2024 Resource Adequacy Plan

Technical Conference #3: Scenarios and Sensitivities/
Modelling Approach and Considerations

October 16, 2024

Forced Outage Rates – Hardwoods & Stephenville GT's

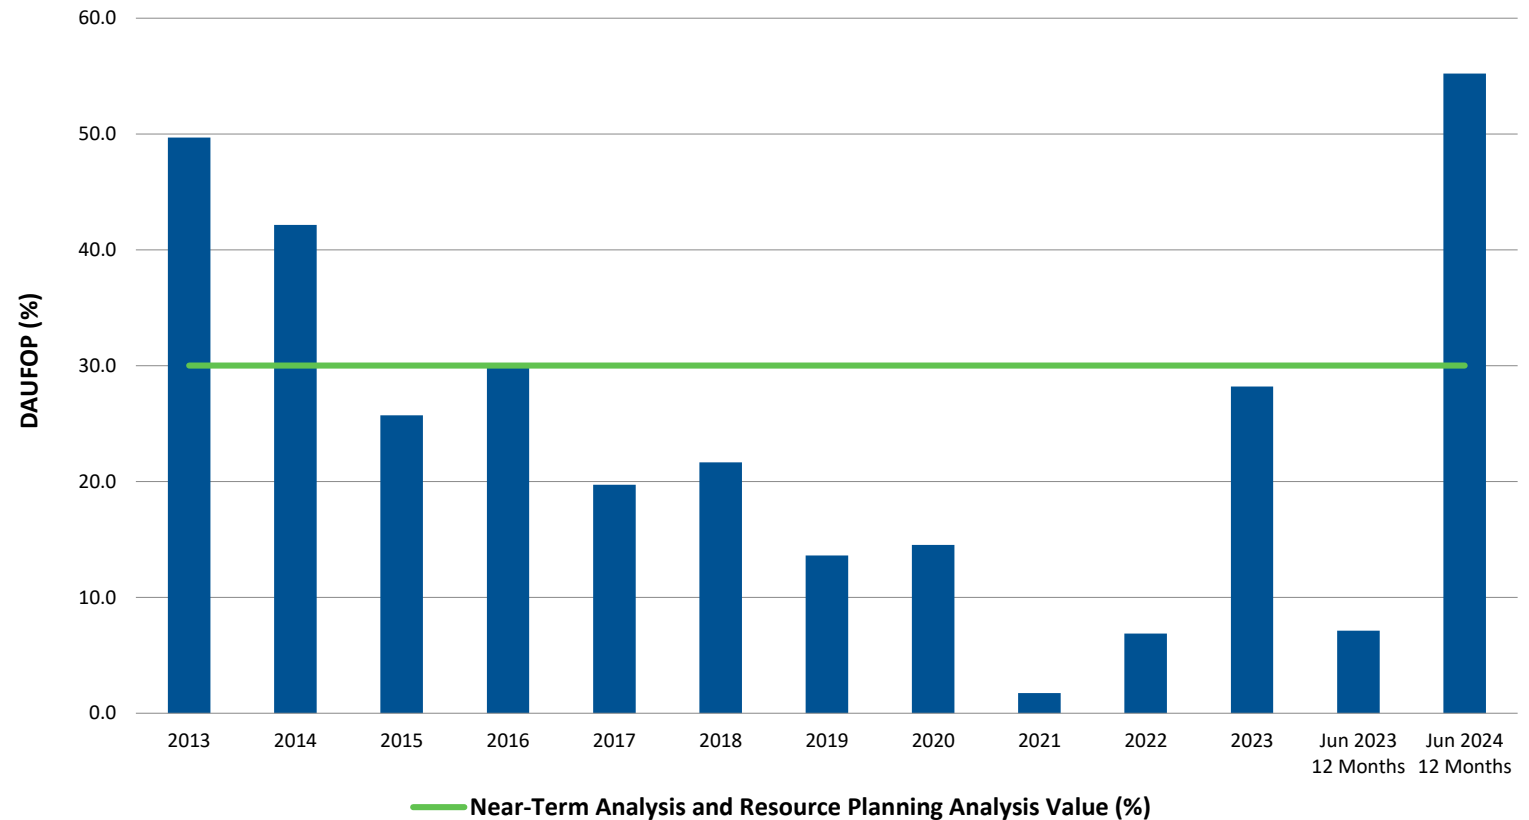
- For its existing thermal assets, NLH used a mix of historical derated adjusted forced outage rates (“DAFORs”), historical derated adjusted utilization forced outage probability (“DAUFOPs”), and equivalent forced outage rates (“EFORd”) reported by NERC. Was this a reasonable approach, do historical data on NLH’s assets support this approach of assumed forced outage rates?*

- **DAUFOP value of 30%**
 - Based on historical data.
- Assumed retired in 2030.
- 2023–2024 impacted by Stephenville unit outage.

Forced Outage Rates – Holyrood CT

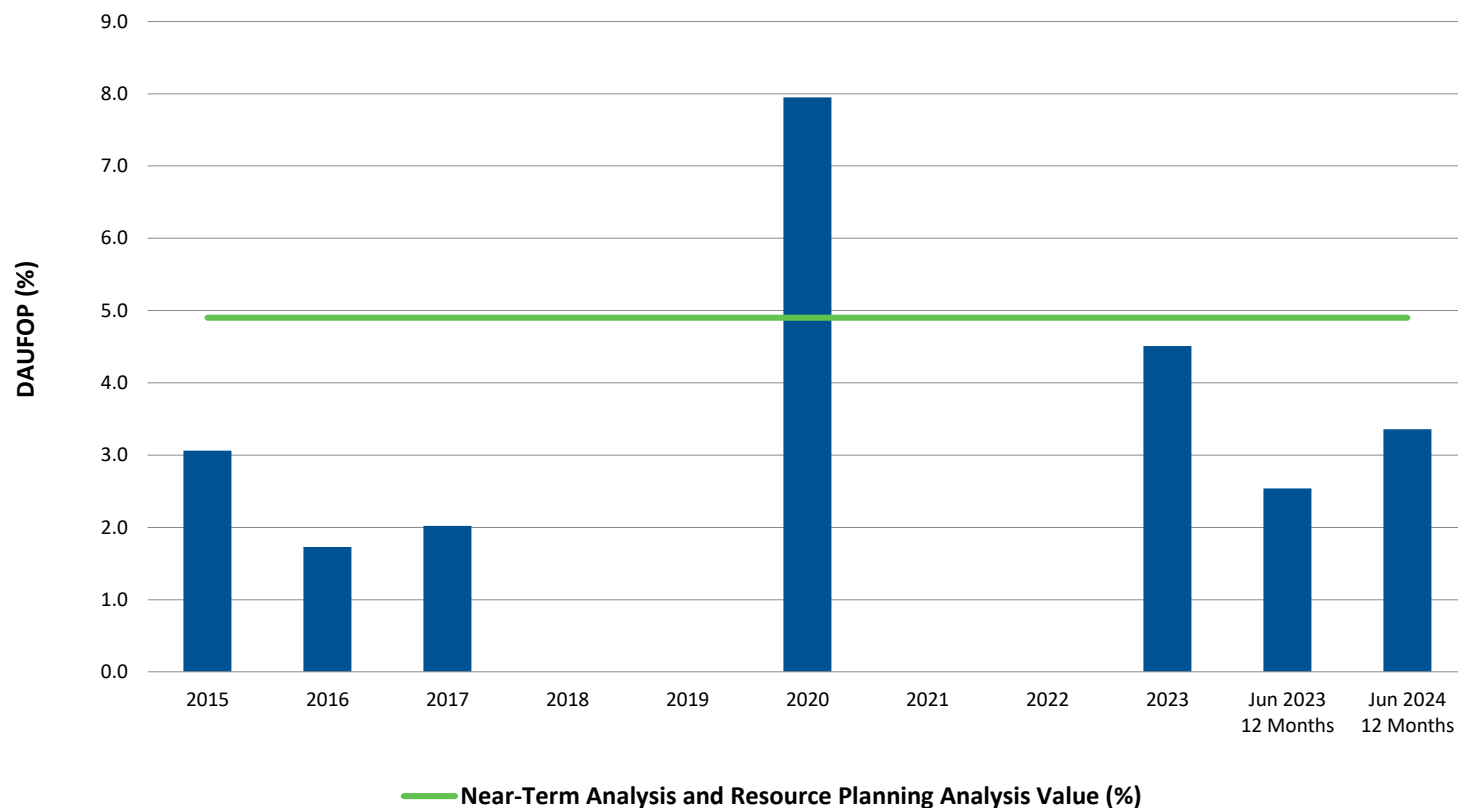
- For NLH’s CTs, NLH used a mix of approaches here to derive the DAUFOP values for use in the “near—term analysis” and Resource Planning Model. Are these approaches and assumptions sufficiently explained, disclosed, and reasonable?*

- **DAUFOP of 4.90%**
- Need-based operation:
 - Yearly and seasonal variations.
- Scenario-based approach for establishing FOR.
 - Helps alleviate the variability year to year.
 - Assumes fixed operating profile.

Firm Energy Requirements – Reference Case to 2042

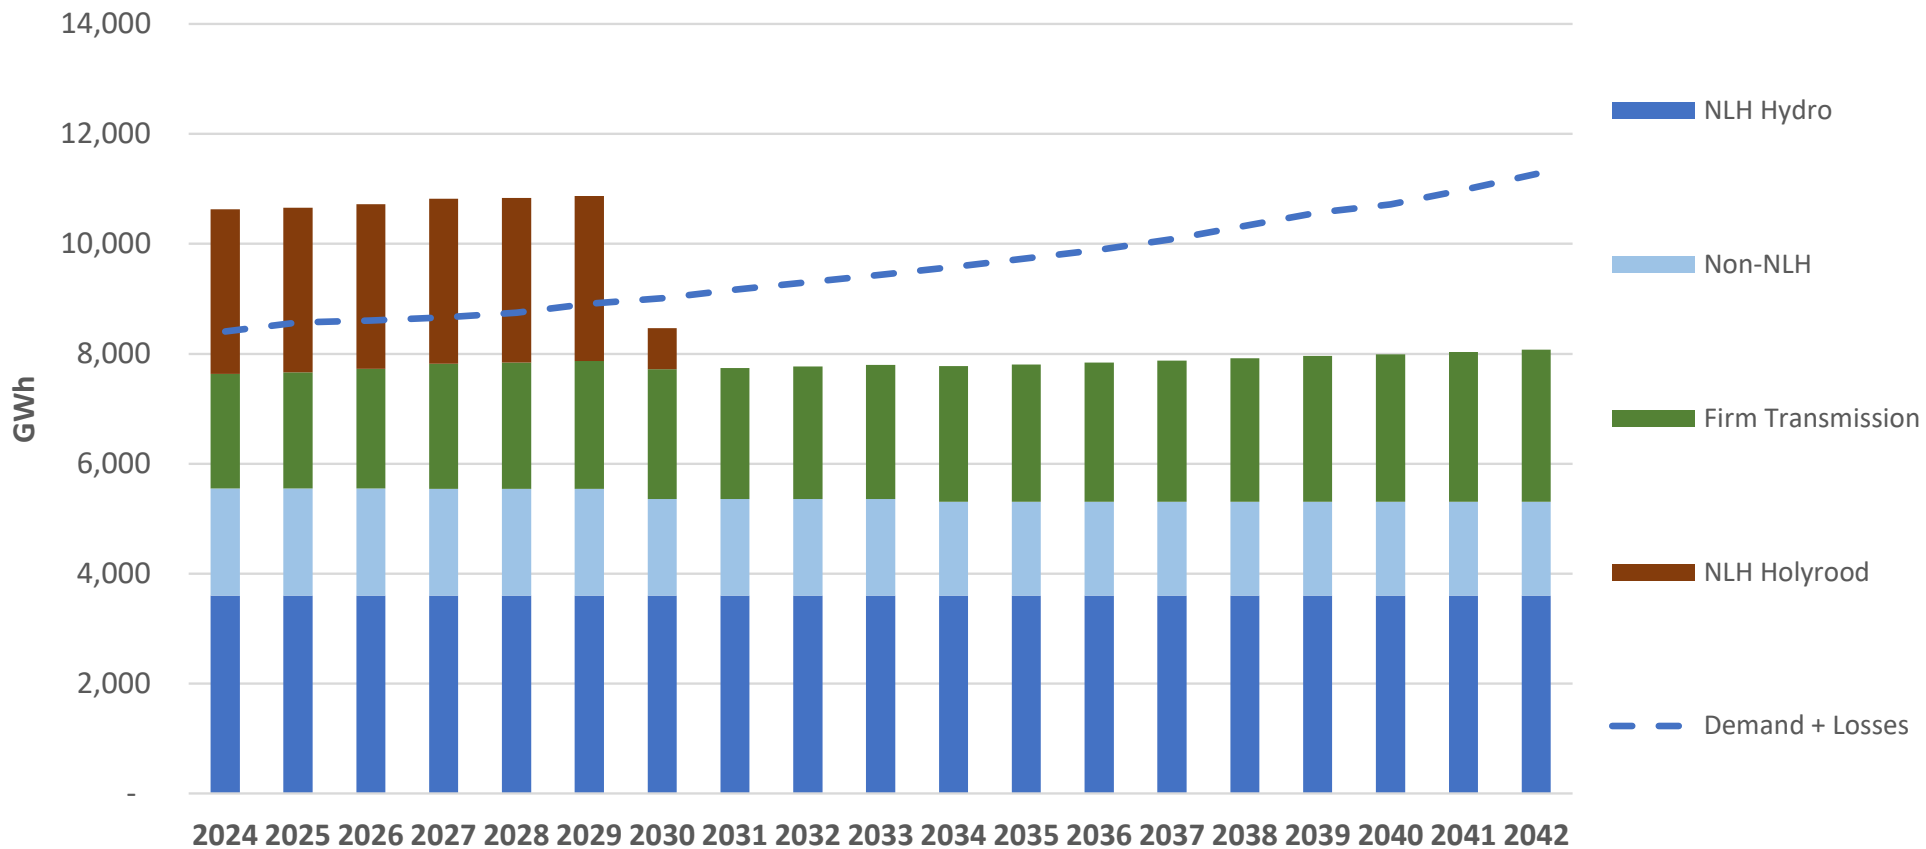
- *Consider incorporating firm energy analysis process into the PLEXOS Model (#45).*
 - *Provide detail regarding transmission losses assumptions and results, hydro spillage, and wind curtailments for its model runs (#49).*
 - *Provide full results of Firm Energy Analysis and explain implications beyond 2034 (#54).*
-

- Firm energy analysis is done outside of Plexos, but will be incorporated into the model in the future.
 - Assumptions
 - Hydro-owned hydraulic generation is based on modelling in Vista and based on the driest three-year sequence.
 - Other hydraulic generation is based on historical minimum generation.
 - Other generation (wind, CBPP co-gen) based on historical averages. Holyrood is based on maximum generation minus outage rates and maintenance.
 - LIL is based on the LIL–Maritime Link relationship and the hourly Island Interconnected System load profile.
 - Other thermal and imports are not included
 - Losses are modelled as a fixed loss factor.
 - Assumed that there is no spillage in a firm energy scenario.
 - Wind curtailments will be studied as part of the ELCC study.
-

Sensitivities: Fixed Wind Profile

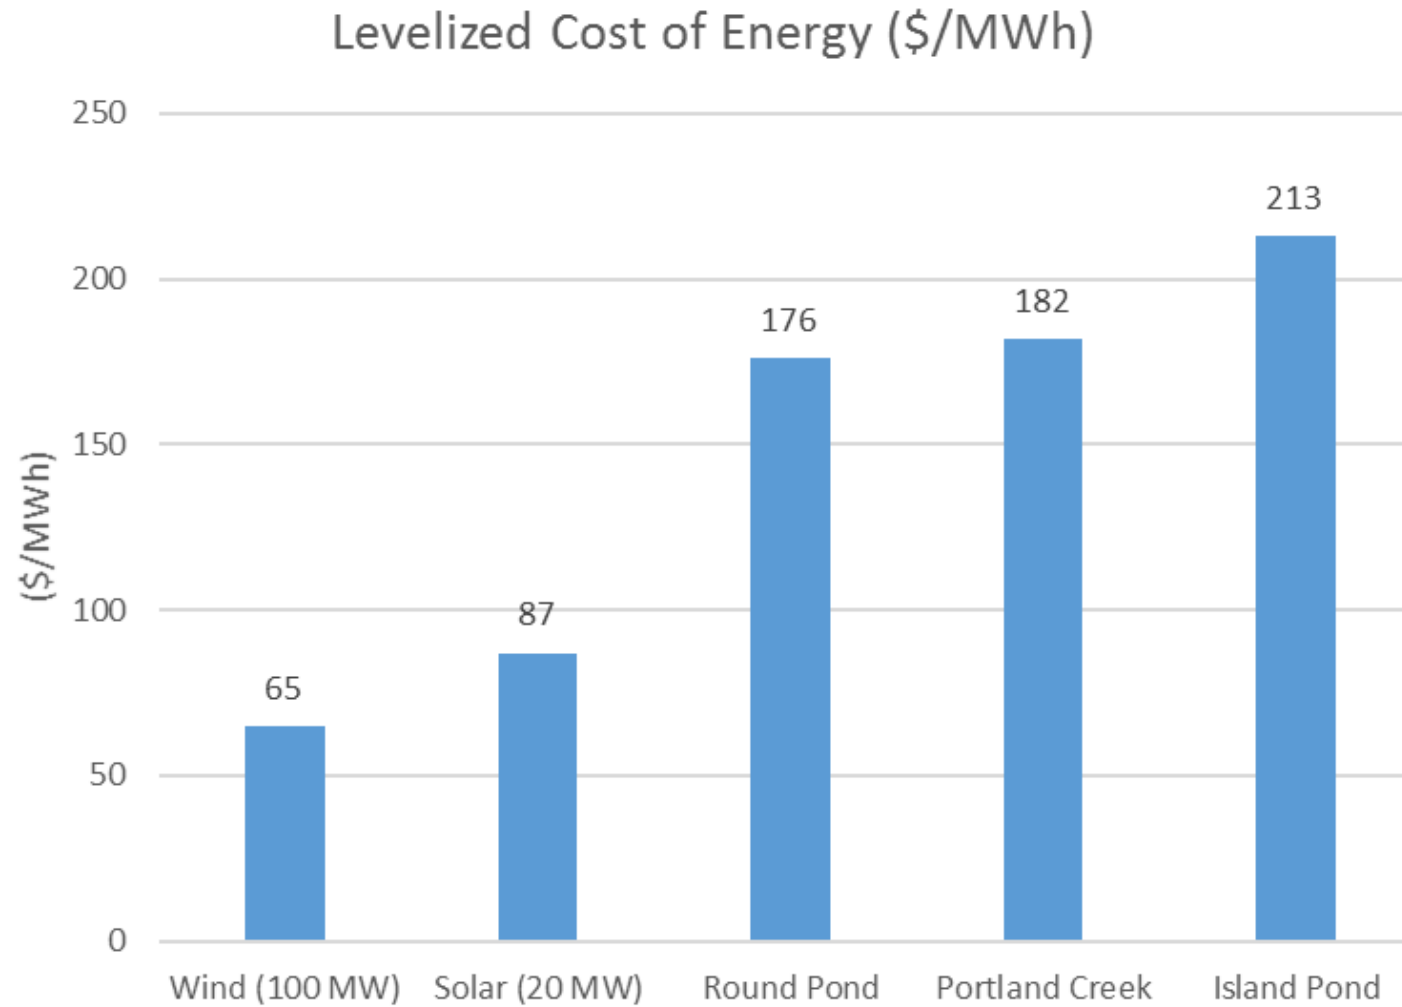
- *Sensitivity A forces the Expansion Model to include sufficient new wind resource to meet firm energy criteria and is carried through in every other scenario, other than the “unrestricted” scenario. Is it reasonable to select wind as the sole technology option to provide firm energy?*

- *Further explore and justify the forced inclusion of wind resources in all sensitivity designs (#43).*

- The first step in the expansion plan analysis was to run an unrestricted expansion plan where known constraints were ignored and the Expansion Model was enabled to determine the least-cost expansion plan.
 - This was done for Scenario 1 (Reference Case) and Scenario 4 (Minimum Investment Required).
- The unrestricted run demonstrated that wind was the least-cost energy solution for each of these scenarios.
 - Other energy providing resource options included greenfield hydro (Island Pond, Round Pond, and Portland Creek) and solar; however, they were not selected by the model as least-cost energy options.

- In the unrestricted expansion plan, while the Island Interconnected System capacity needs are met, does not meet the firm energy criteria requirement.
- Scenario 4A (Fixed Wind Profile) does meet the firm energy criteria requirement.
- The difference between each sensitivity is highlighted below for Scenario 4 (Minimum Investment Required).
